### **Review #1: Planning Dept - Matt Fitzsimmons**

Deyoung Addition & Remodel 9445 Shoshone Rd., Cascade, Co

Cover Sheet & Site Plan

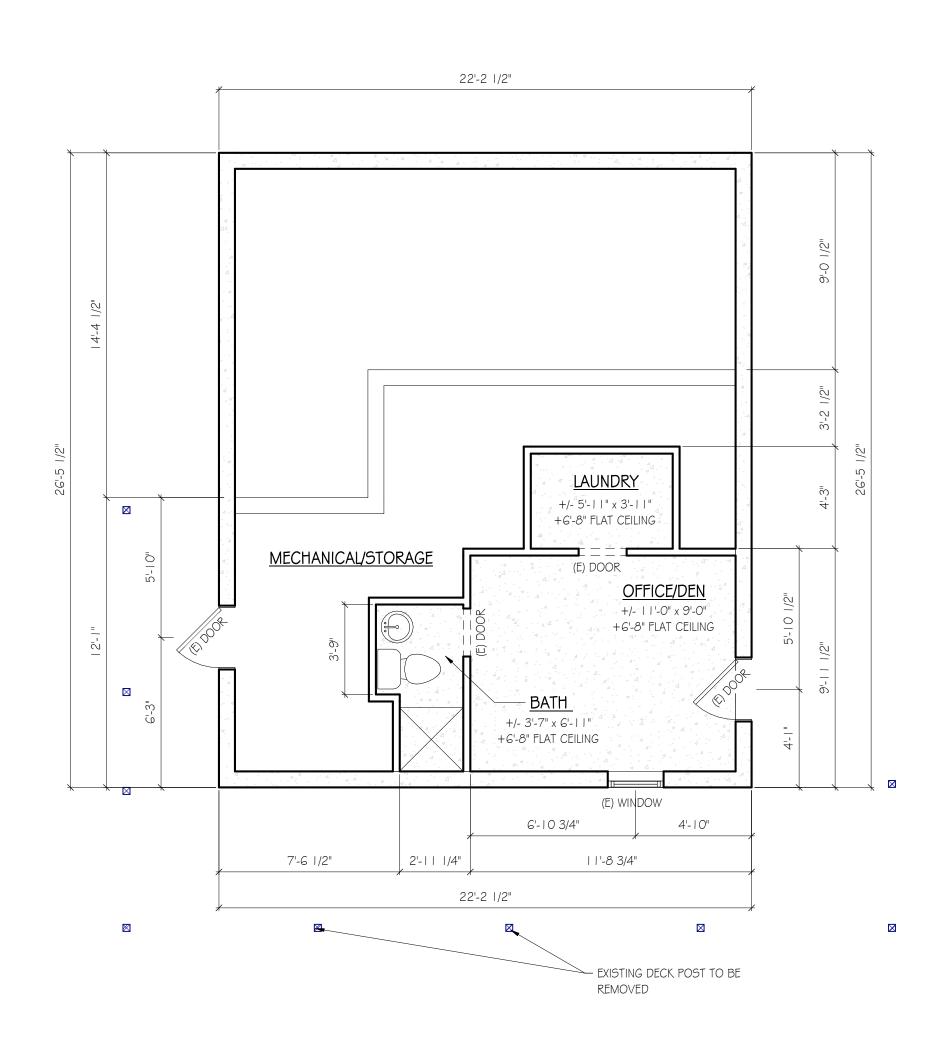
- 1. General site notes are repeated, please delete one of the notes.
- 2. Please include a one or two sentence description of your project with the list of variances requested on the site plan.3. List the site dimensional standards for the R-T zone and indicate what this project is proposing next to it:

- Minimum Lot Size: 5 acres 0.19 acres existing
- Minimum Lot Width at Front setback (25') = 200ft.
- Minimum Setbacks Principal 25' for the front, side and rear

- Maximum Lot Coverage: 30%
- Maximum Height: 30'
- 4. Include a Bar scale
- 5. If the drawing is to scale, I estimate the addition to be about 24'5" from the property line, where 25' is required. Please amend or request administrative relief for. Please draw the side setbacks as 25', not 5'.

- 6. The proposed addition and deck will be within the 25' side setbacks unavoidable. That shall be noted for both sides.
  7. The lot size, frontage width, and existing house location

- exist already. Provide proof that they existed when you purchased the property on 2021. Can you prove they are legal non-conforming?
- 8. Indicate the height of the proposed deck on page 1.9. Are there any easements on the site? If so, please include

- 10. Include the information that includes the adjoining property owners, uses and zoning.
- 11. please place the project number: BOA223 at the bottom right corner.
